Proposed Changes to IEEE Std 802.3, Sub-clauses 25.4.5, 25.4.5.1  
and 25.4.7, to address the need for reduced Open Circuit  
Inductance in Ethernet Magnetics

Revised August 25, 2011  
August 2011

Figure 25-1—Type 2 system time constant test circuit

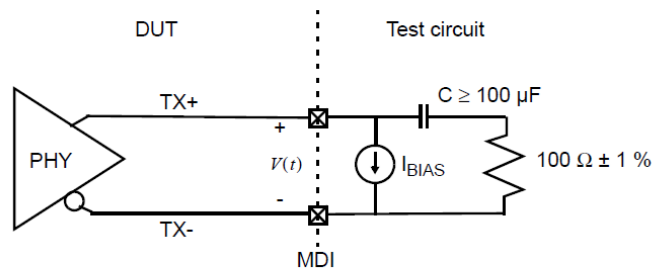
4. Change the Note for Figure 25-1 in section 25.4.5.1

NOTE-For transmitters in a Type 1 or Type 2 PSE or PD,  $I_{BIAS}$  is the current  $I_{unb} / 2$  defined in Clause 33. For transmitters not in a Type 1 or Type 2 PSE or PD,  $I_{BIAS}$  is not required.
